4-December-2020

RE: Response to Technical Evaluation Comments and Information Request  
#4 for Underground Injection Control (UIC) Permit Application Class VI  
Pre-Construction Permit Application No. R9UIC-CA6-FY20-1

Figure 14: BB Co. 1 wellbore after P&A operation

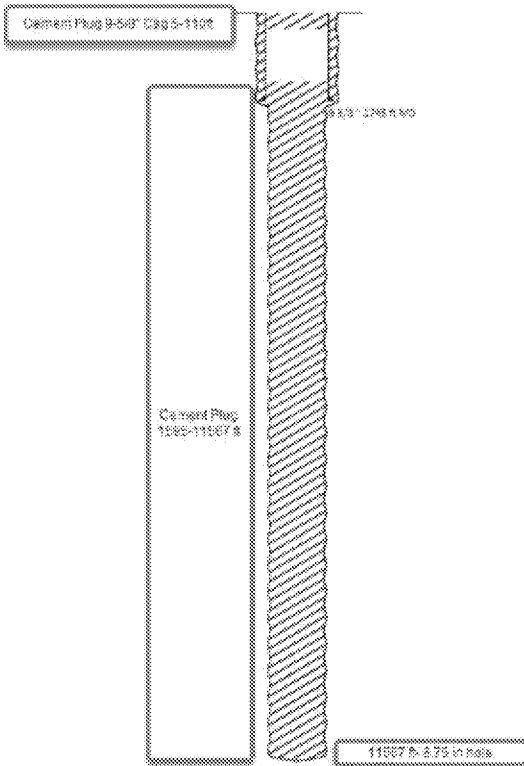
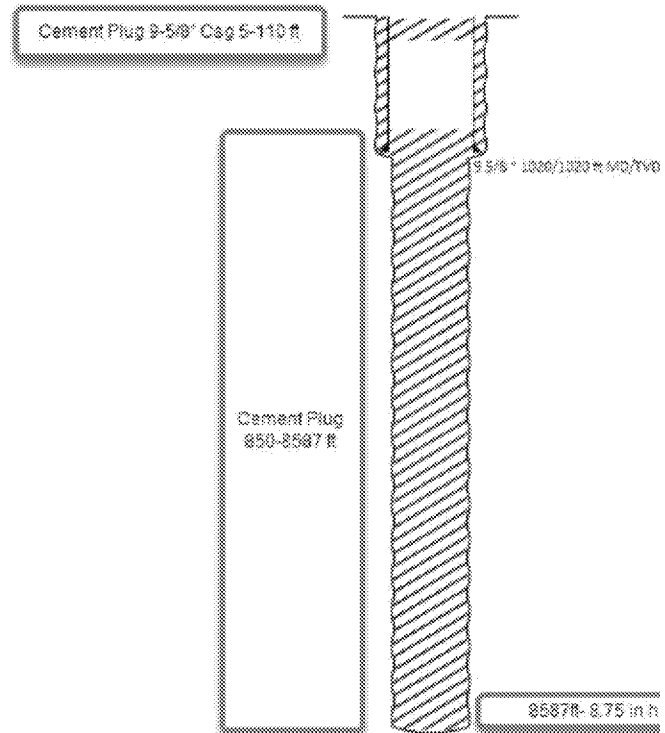
- *The plugging procedures for Amstar 1 and BB Co 1 on pages 25 and 26 reference a casing diameter of 9 5/8 inches; however, figures 14 and 15 show that the hole is 8.75 inches. Please clarify the discrepancy.*

- *Comment noted. Attachments and plans will be corrected accordingly.*
- *Figure 46 of the permit application narrative shows the centroids of the water well locations. Please provide verified actual locations of the water wells.*
- *Please refer to **Error! Reference source not found.** in Appendix A of this document for surface locations of GW1 to GW4 shallow monitoring wells. These are the proposed monitoring well locations that will be drilled.*

Figure 5-1. Mendota INJ 1 well schematic, including gauges and USDW. Updated figure.

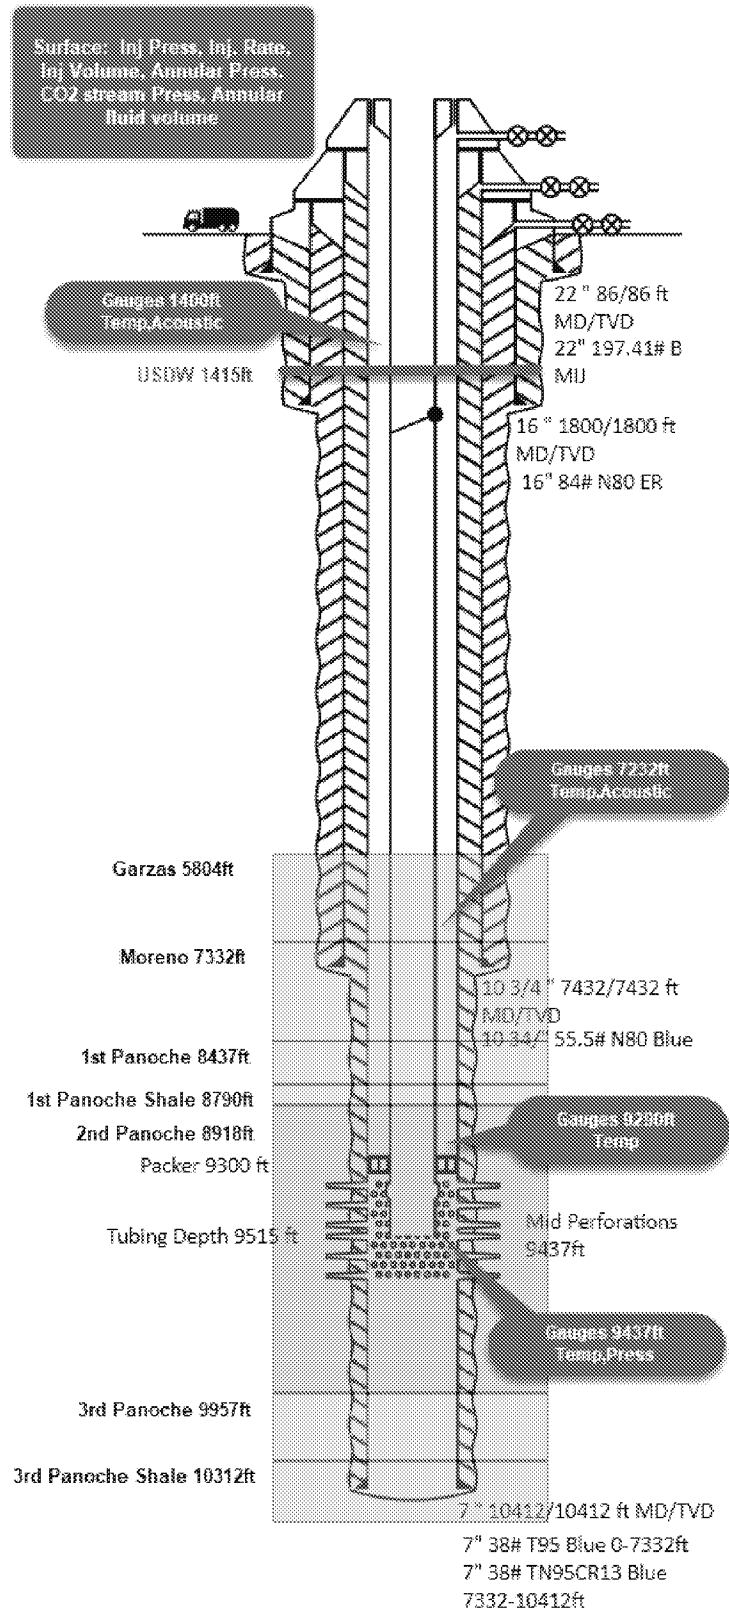
- Please describe more explicitly the location/depth of the pressure/temperature gauges at the packer.
- Please refer to Figure 5-1 in Appendix B for a well schematic that includes gauge placement and type.

- *Comment noted. CES does not anticipate entering zones of significant water or hydrocarbon saturation at the planned well plug sites. Figure 5-1 of Appendix B illustrates the Moreno and Panoche formations as well as the primary injection zone relative to the well plugging schematic.*
